**FINAL DRAFT  
REPORT**

**Clarksburg - Ten Mile Creek Area  
Sewer Facility Study**

Washington Suburban  
Sanitary Commission

March 2, 2015

# Figure 3-4 Alternative 4: Gravity + 4 Pump Stations

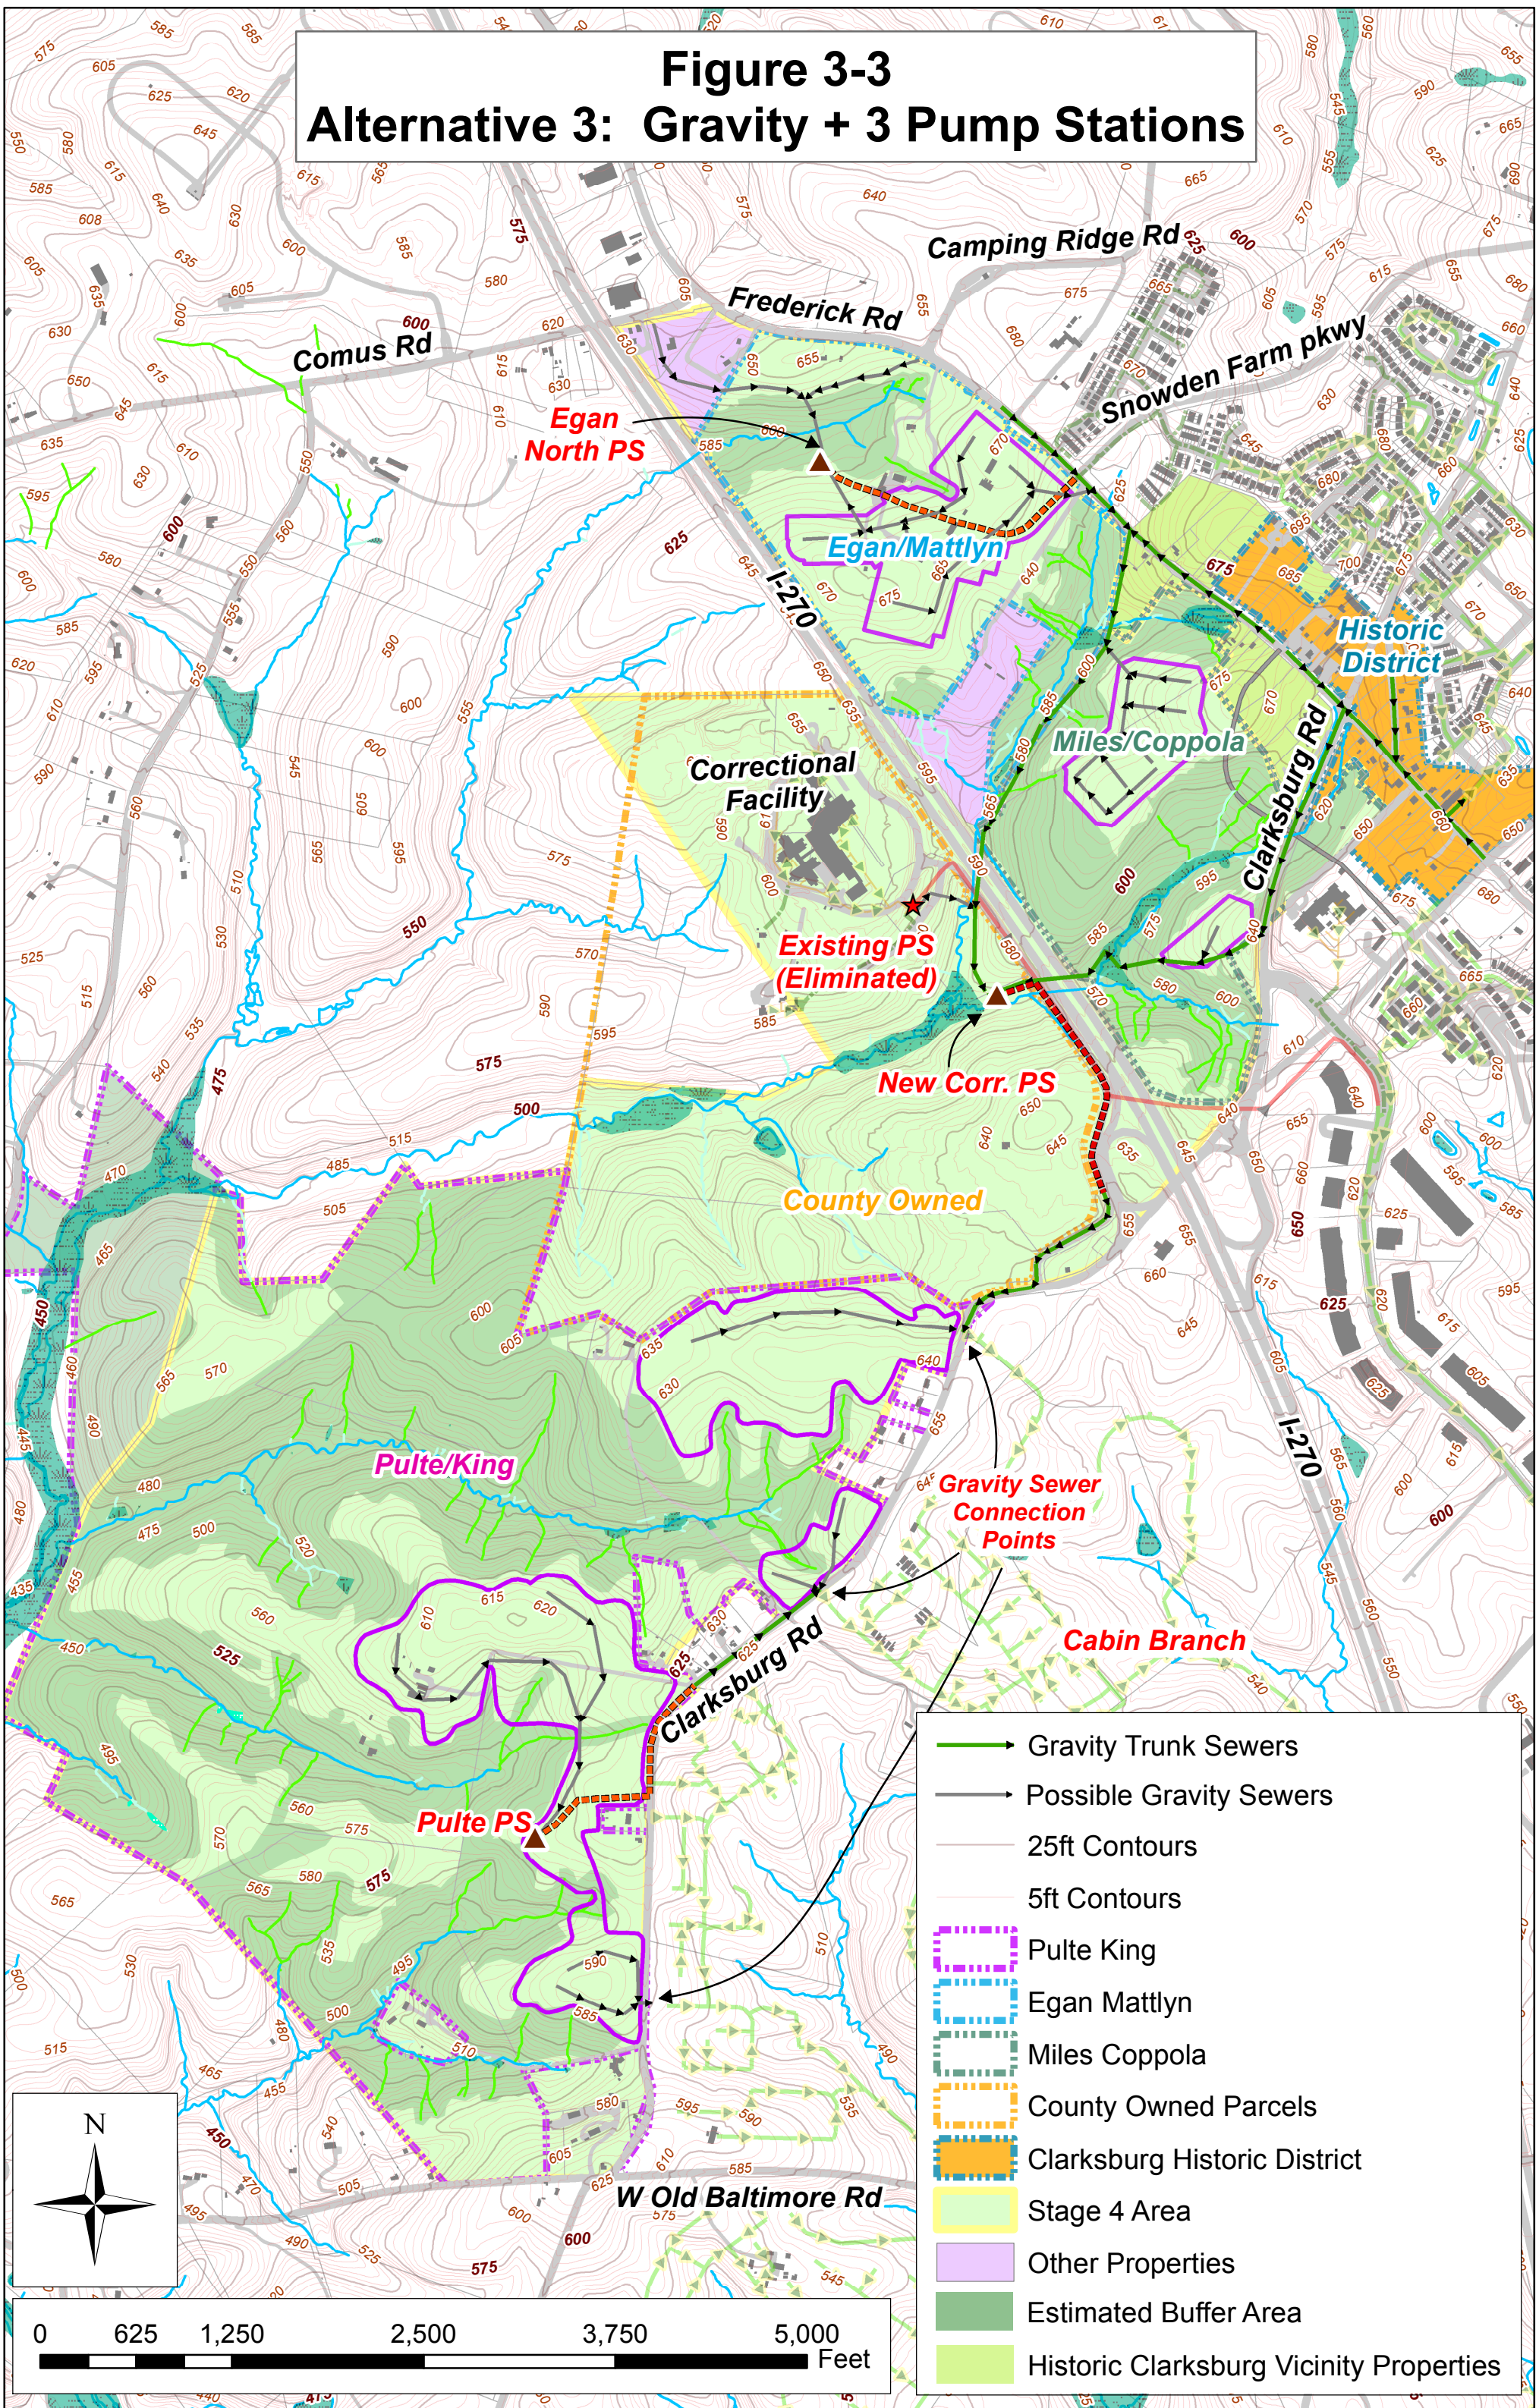
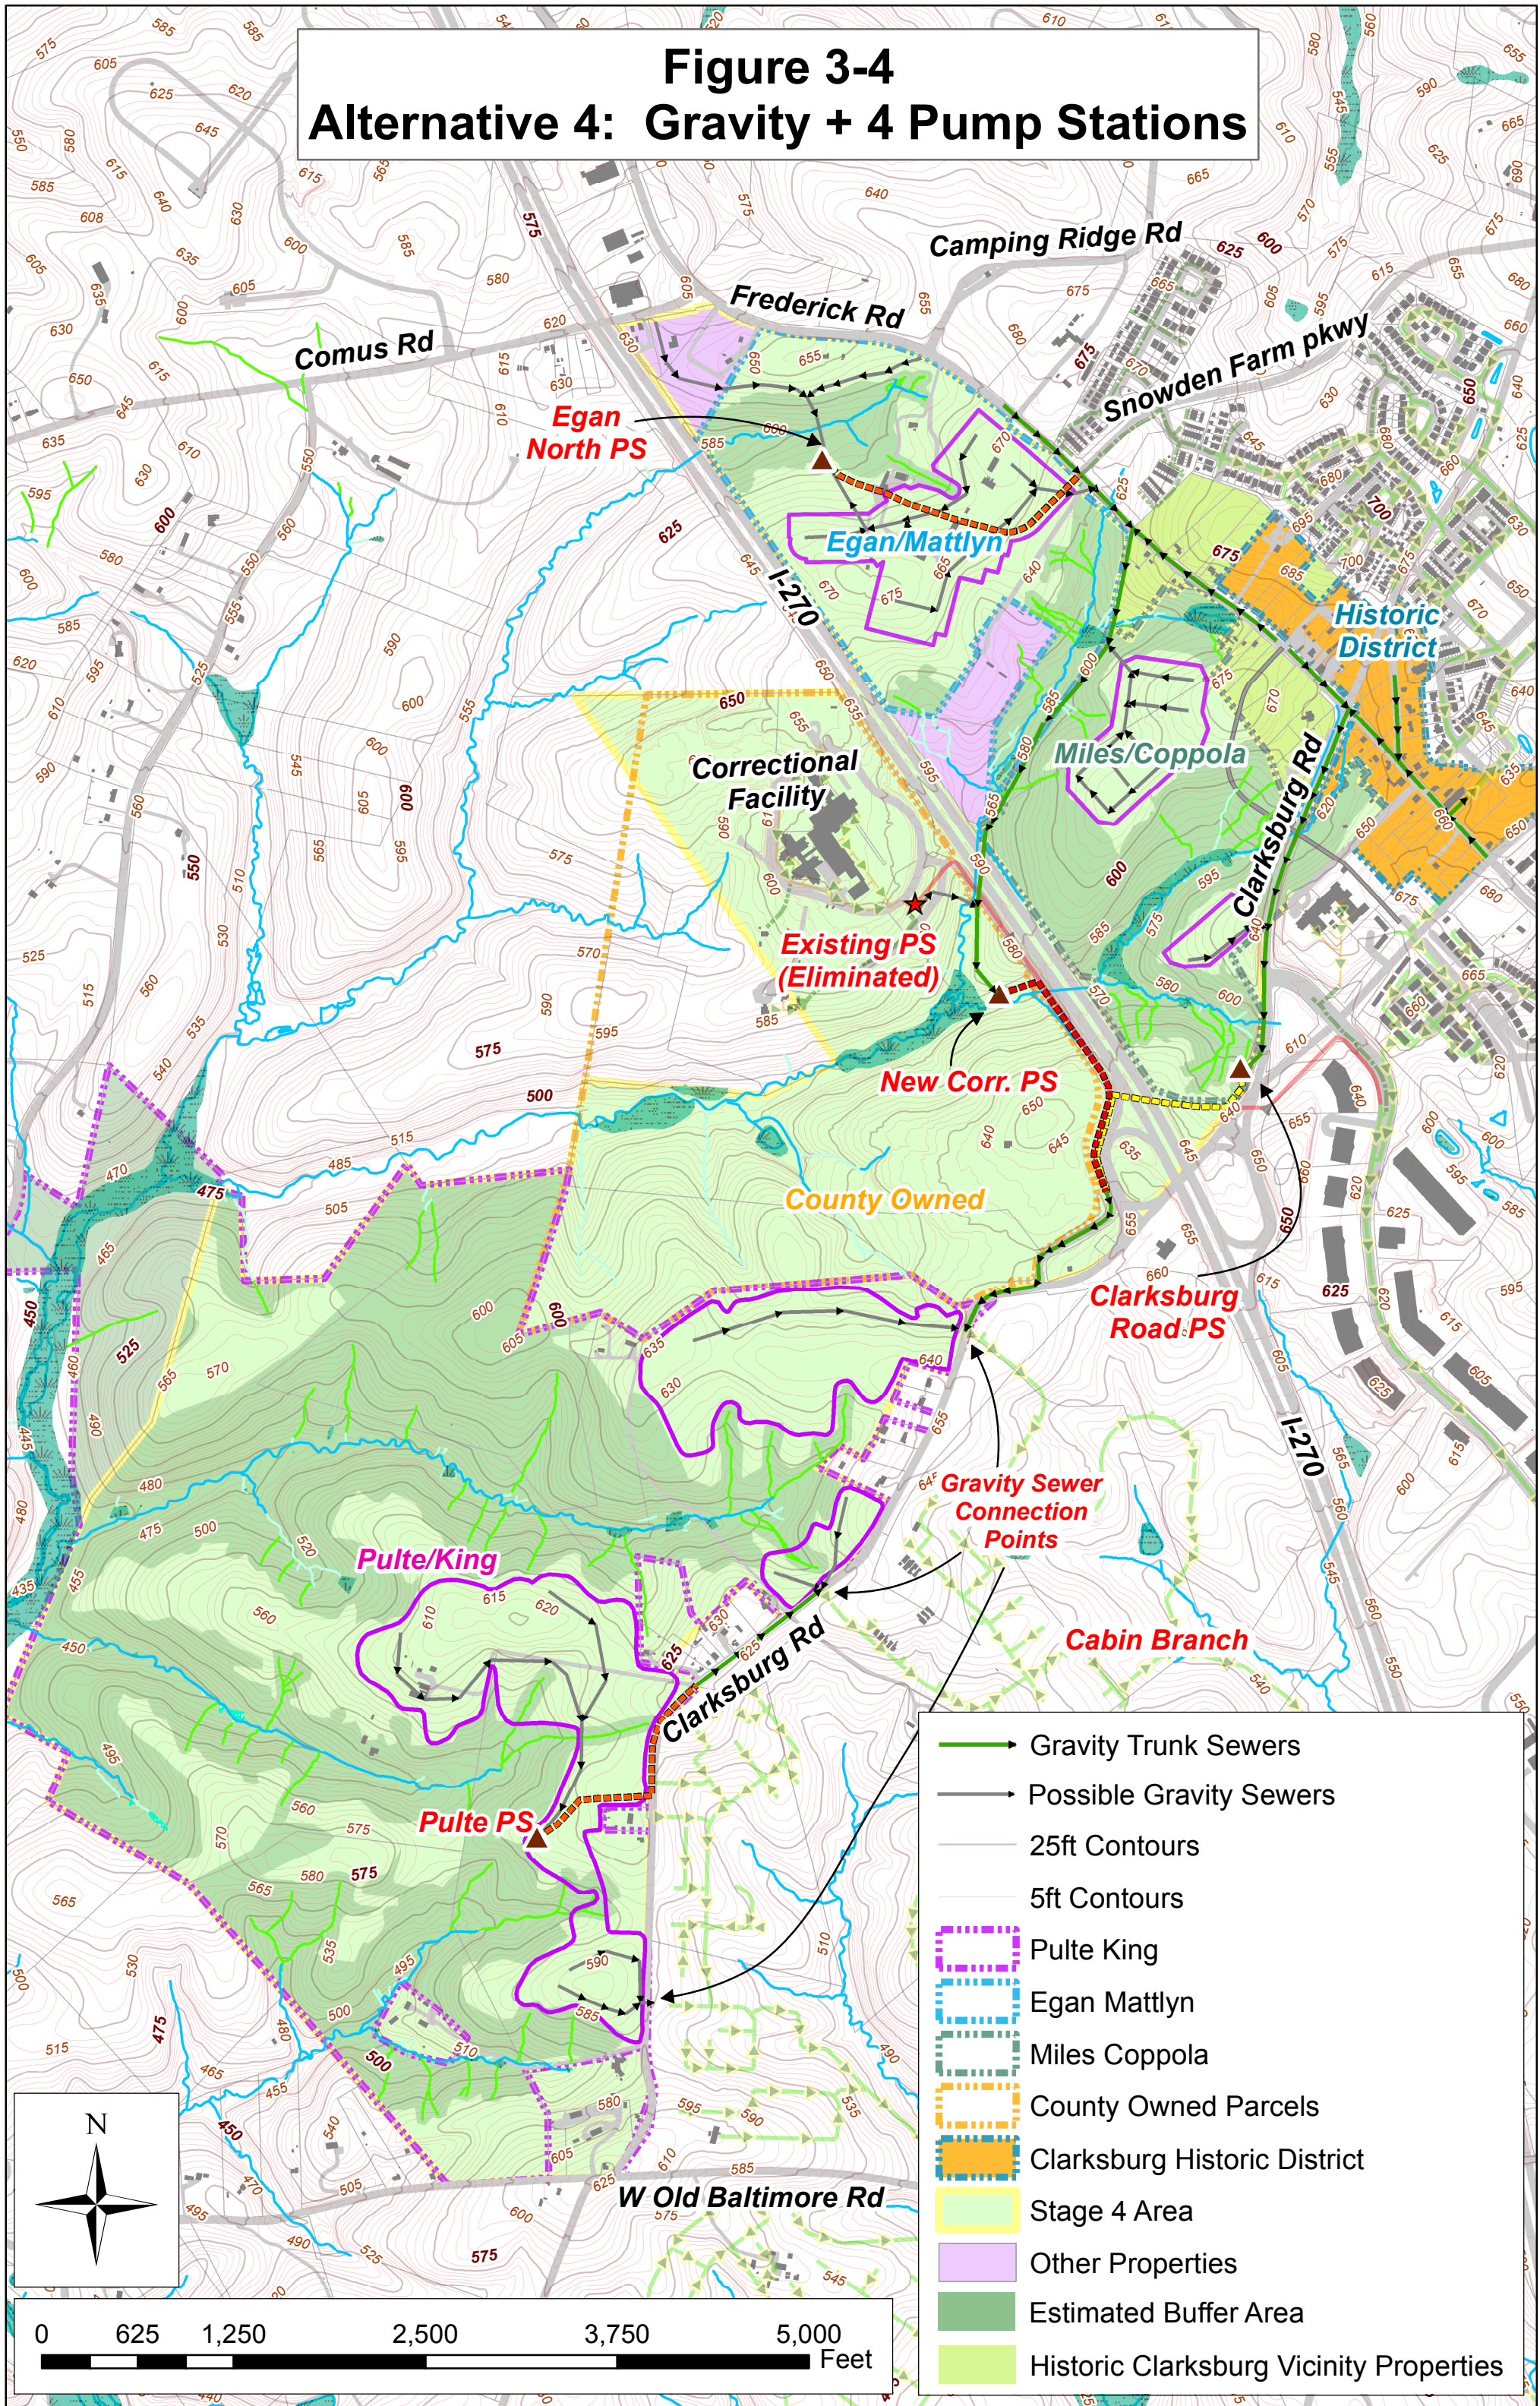
40	12/18/2015	Jay Cinque, Anne James, Cathy Wiss, (CAC Members)	<p><b>5. Remaining sewer issues</b></p> <p><i>c) On the maps for each of the alternatives, sewers in the southern part of the Pulte property appear to stop abruptly. We understand that they will connect to planned sewers in the Cabin Branch watershed that have not yet been built. A notation of this planned connection would be helpful on Figures 1-2, 3-1 through 3-10, 4-3, and 4-4.</i></p>	<p>Revised figures 3-1 through 3-12 in the Final Draft Report to address the comment</p>
41	12/18/2015	Jay Cinque,	<b>5. Remaining sewer issues</b>

<b>46</b>	12/21/2015	Katherine E. Nelson Planner Coordinator M-NCPPC	<i>5. Figures 3-1 through 3-10 (the Alternatives) – These figures identify “Buffer Areas”. Since these buffer areas have not been determined yet, they should be identified as “anticipated” or “estimated” buffers. These figures should also identify all existing and future gravity sewer connection points on the east side of Clarksburg Road.</i>	Revised figures 3-1 through 3-12 in the Final Draft Report to address the comment
<b>47</b>	12/21/2015	Katherine E. Nelson Planner Coordinator M-NCPPC	<i>6. Tables 4-1 through 4-8, pages 4-2 through 4-5 – Long-term operation and maintenance should only include the O&amp;M that will be performed at PUBLIC expense. At the very least, the difference between public and private O&amp;M should be shown. This relates primarily to grinder pumps located in private homes.</i>	Cost tables in Section 4 of the Final Draft report were revised to provide additional clarity. Private capital and O&M expenses and the pump station to be built by WSSC are identified in the revised cost tables. Generally, infrastructure projects need to provide sewer service to a property is built by the developers. Some of these projects may be eligible to receive System Development Charge (SDC) credits. This is determined on a case to case basis. Identifying funding mechanisms for construction of the critical infrastructure needed to serve the entire project area is beyond the scope of this current sewer study. Long term O&M costs for pumping stations is borne by WSSC,
